WATER PERMIT NO. 8898-3

Name of Applicant: Good Samaritan Society – Founders Crossing

SOUTH DAKOTA
WATER PERMIT NO. 8898-3

OVERALL SITE LAYOUT

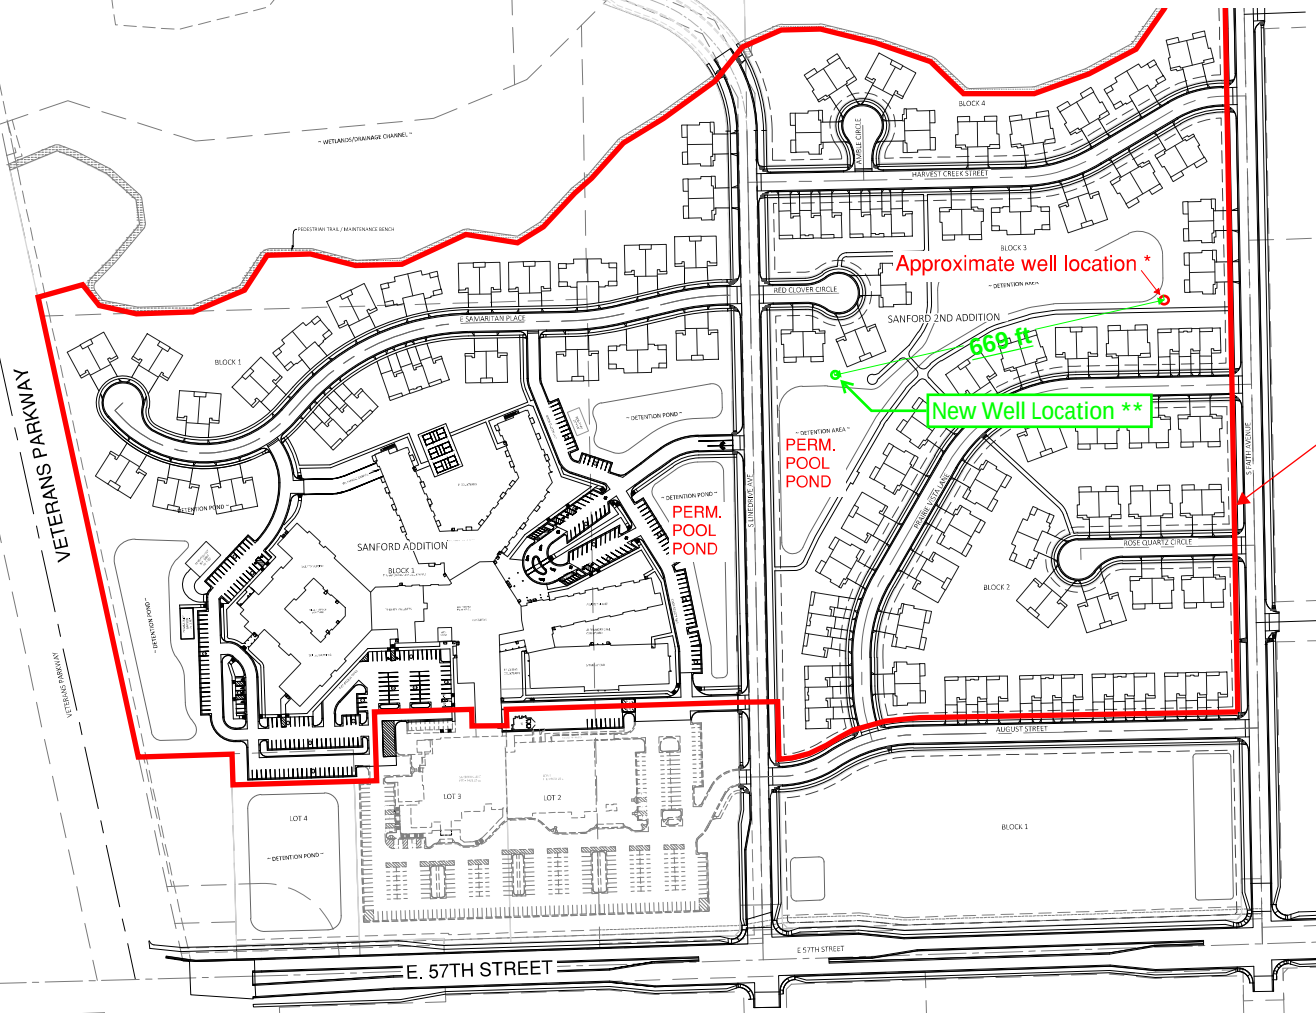
Notified by Myon Adam with JSA Engineers on March 20, 2025, the location of the proposed well is being relocated as shown on this map. The new location is within the diversion point area on Permit No. 8898-3. I informed Mr. Adam no further action is needed by the Good Samaritan Society.

**** Revised Well Location**
 SW 1/4 of Section 31-T101N-R48W
 Latitude: 43d30m12.75s N
 Longitude: 96d38m40.18s W

OVERALL SITE LAYOUT

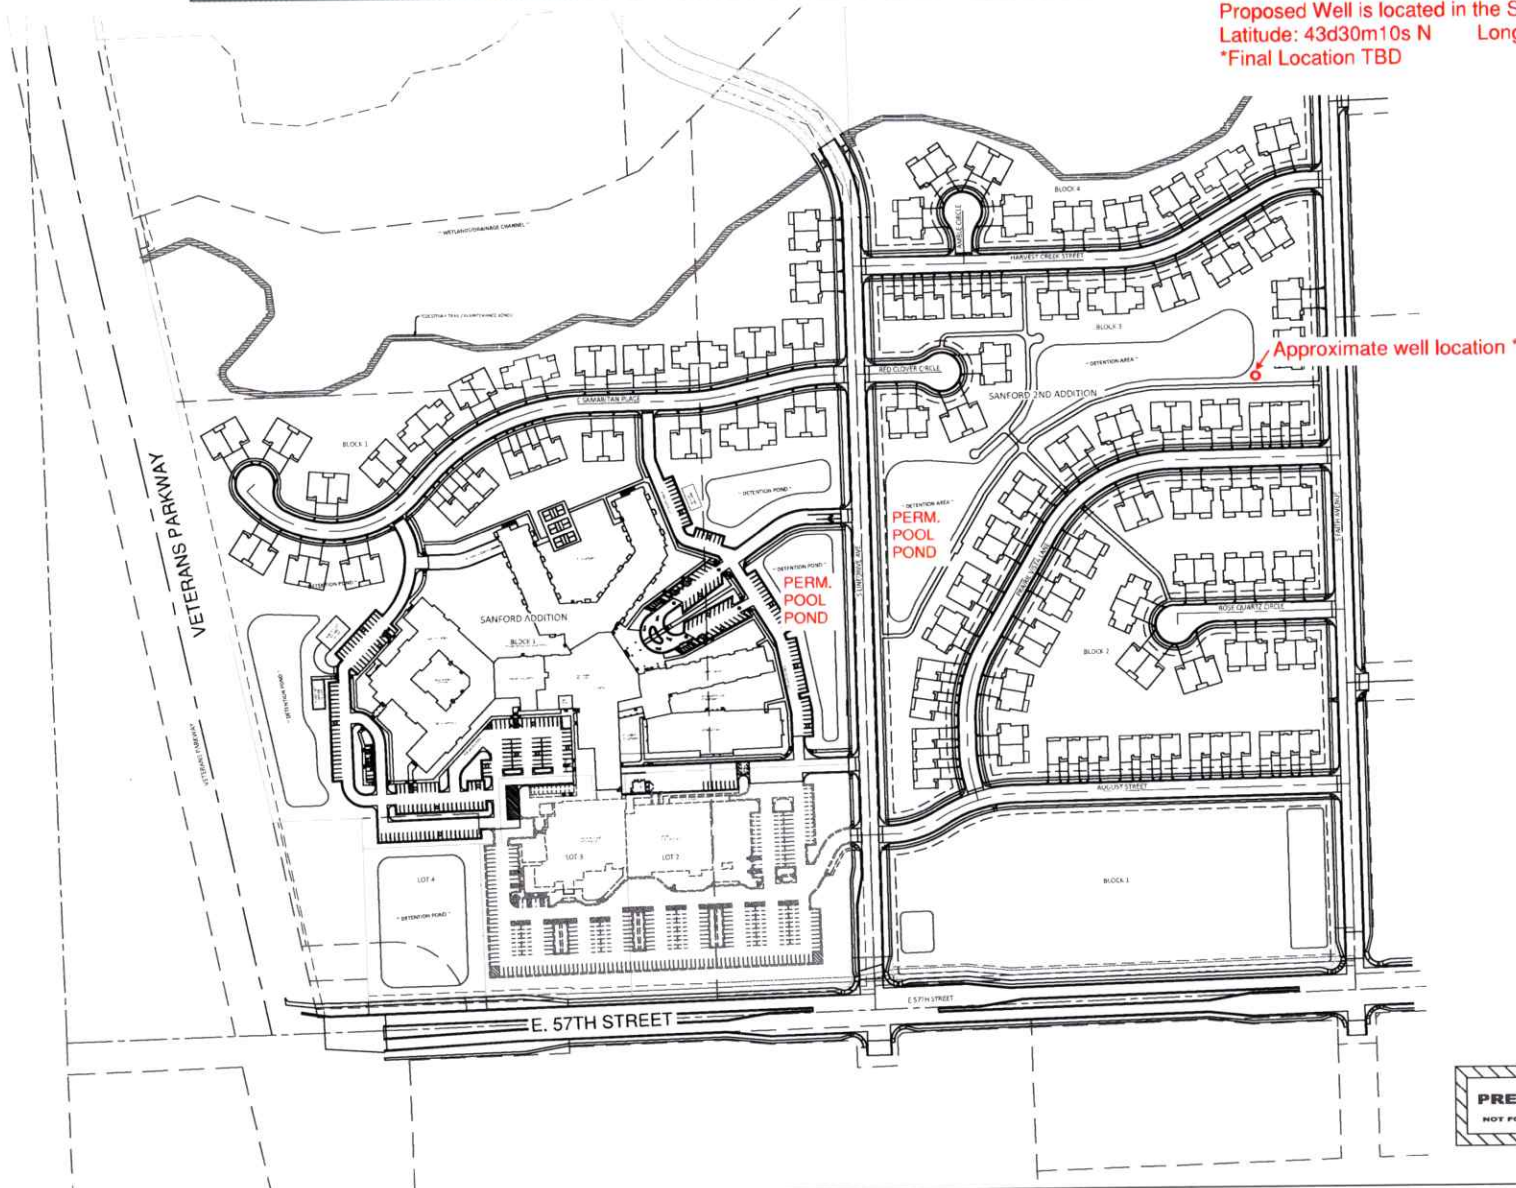
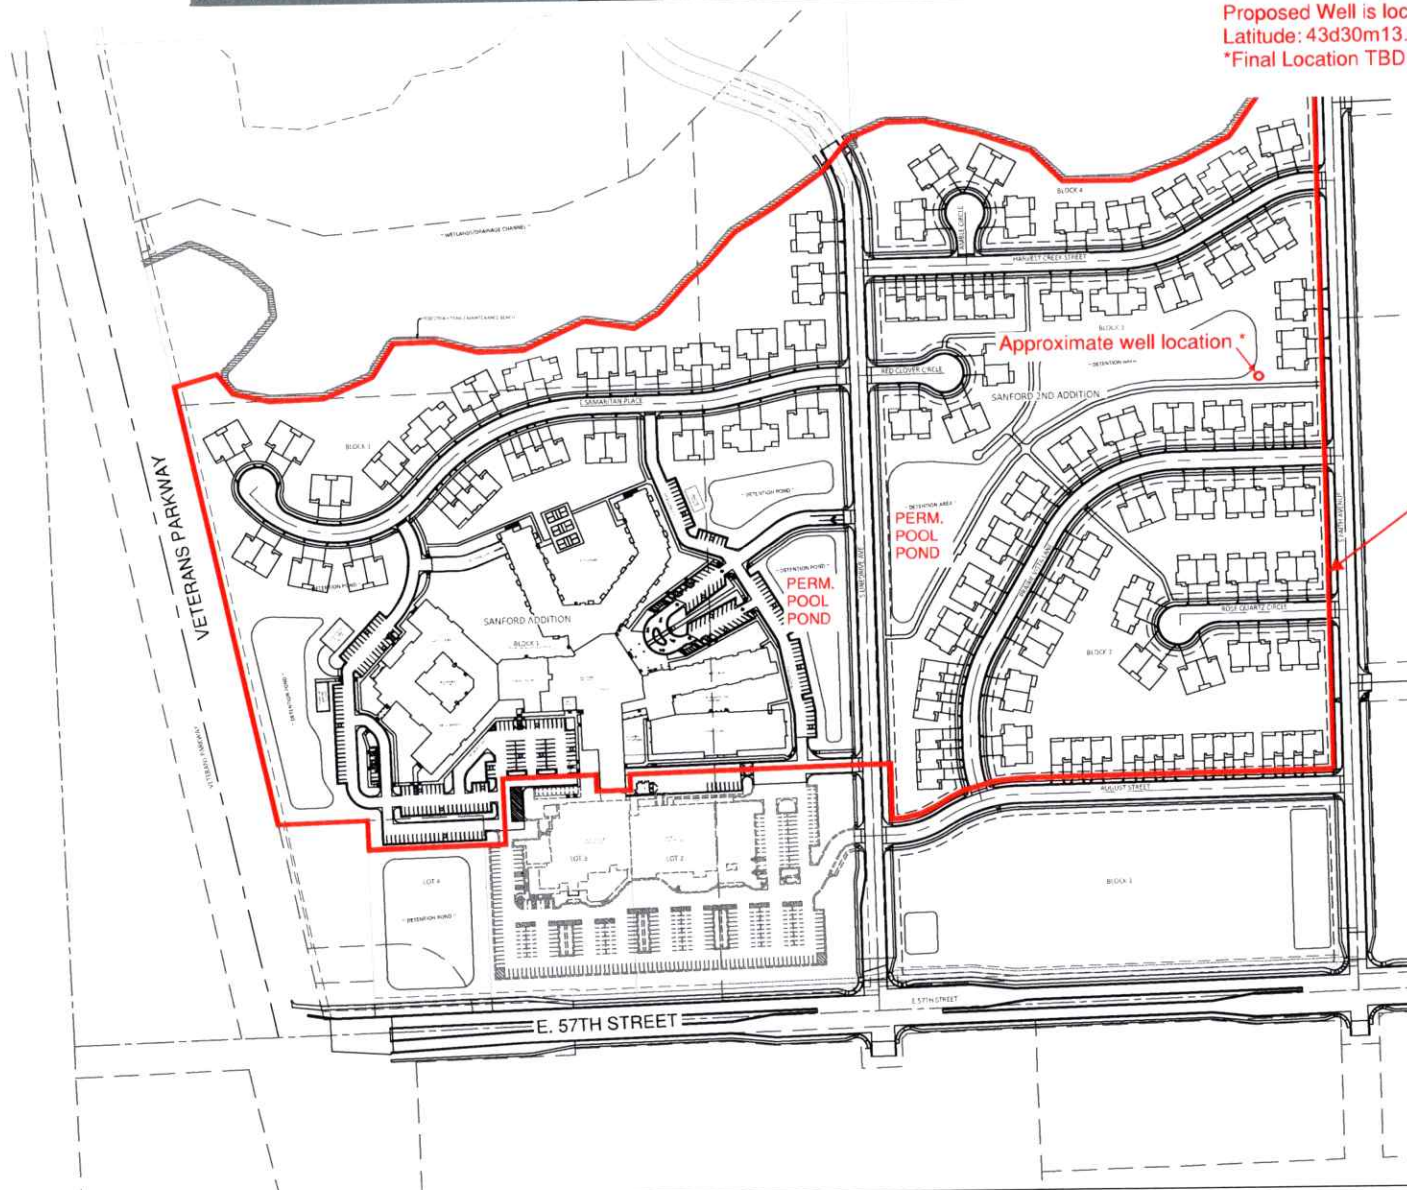
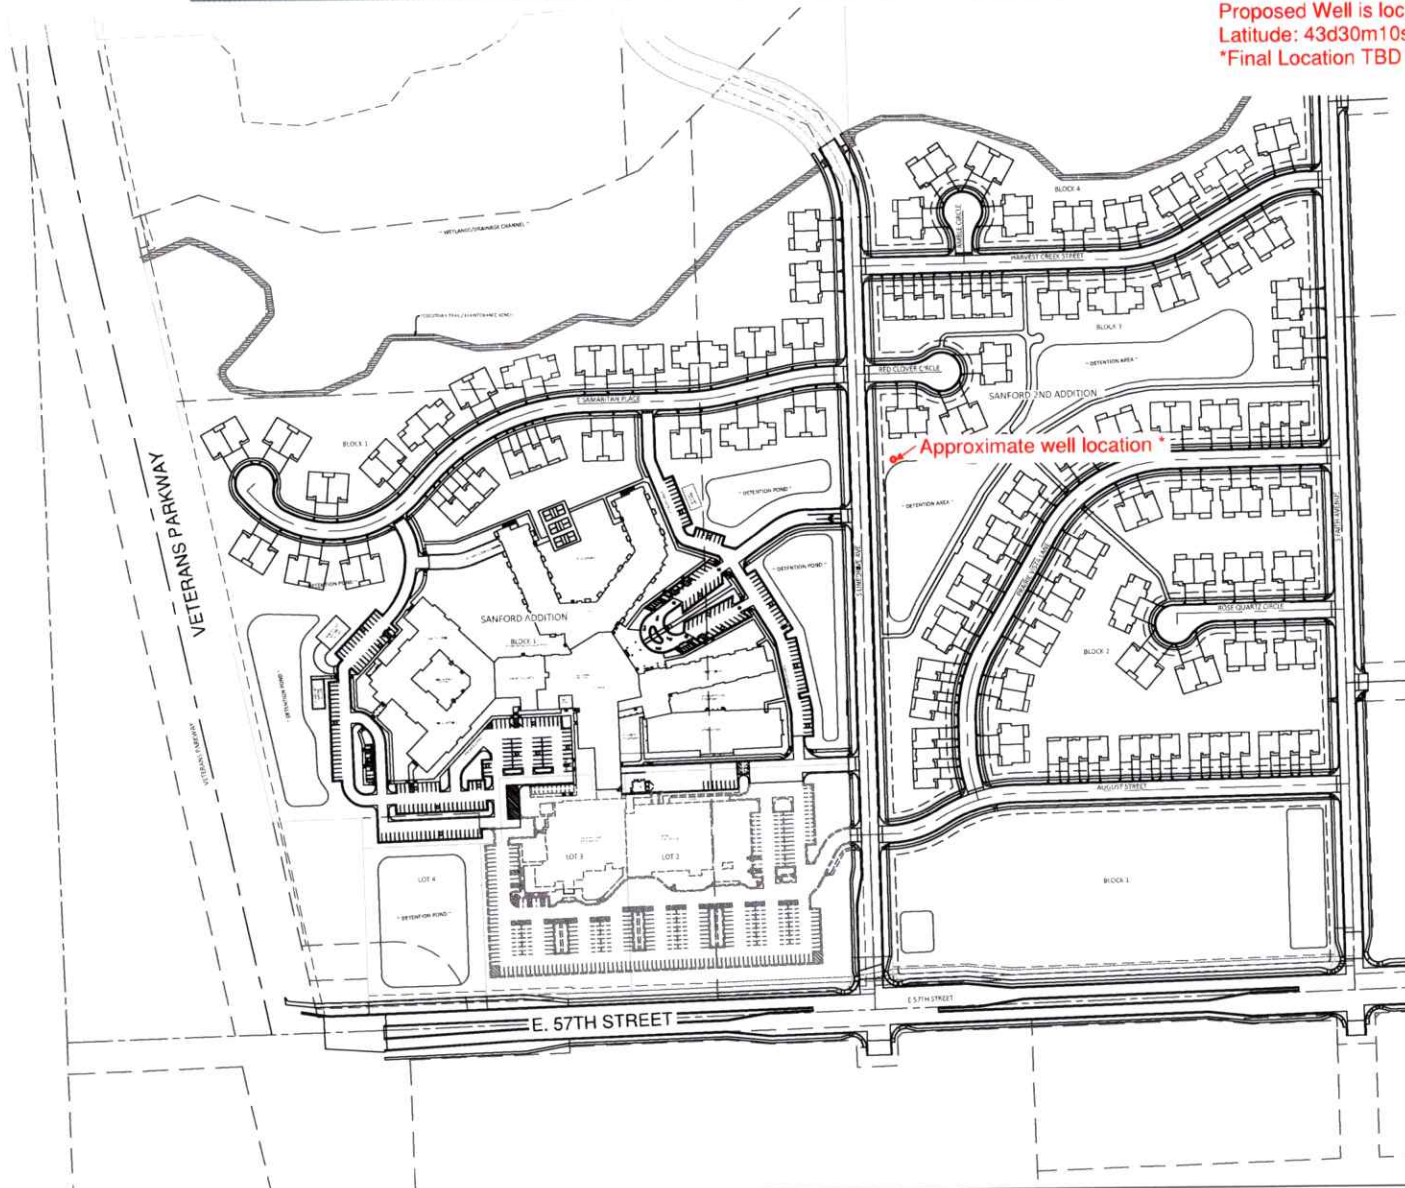
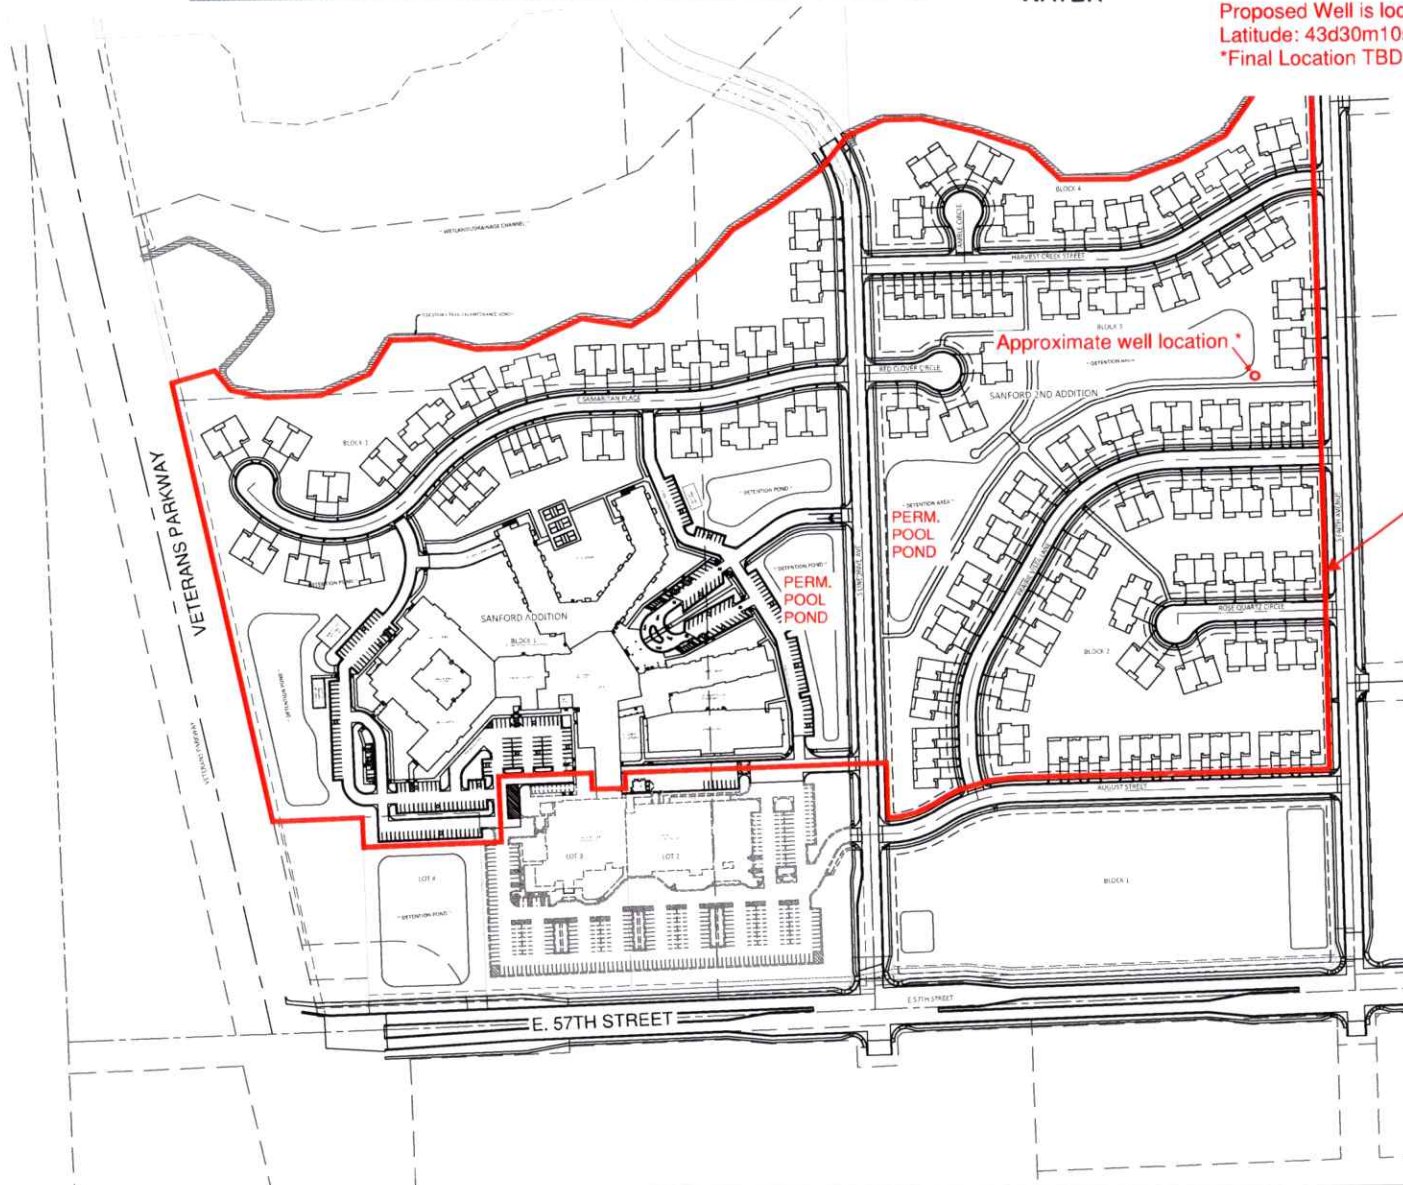
Thanks for the responses. Since a major use of the water is irrigation, the application should also identify "irrigation" along with "institutional" use. The "institutional" aspect will amount to having the water for aesthetic purposes as noted on the application. Also, since irrigation is a major use, the area encompassing the 28.5 acres should be identified on the map. I don't know whether the 28.5 acres is the area surrounding the main facility near the intersection of Veteran's Parkway and 57th Street or whether the acres include the entire area identified on the map already submitted. I ask because the public notice will need to identify the legal description of the diversion points (well and two ponds) and the area to be irrigated.

2. In looking at the map I count, I count five detention ponds. You indicated in your response to Rachel there will be two permanent pools (presumably with water levels maintained by the well) and ponds may be used to water the grounds. Are the ponds to be used to water the grounds the two permanent pools and which of the five detention ponds showing on the map are the permanent pools? Three of the five ponds are "dry" stormwater detention ponds to control stormwater runoff. The two permanent pool ponds are labelled on the attached exhibit for your reference/clarification.

I updated the coordinates with additional precision to attached proposed well location.

I also updated the application for an "institutional" use, adjusted the proposed well location and labeled the permanent pool ponds on the exhibit.
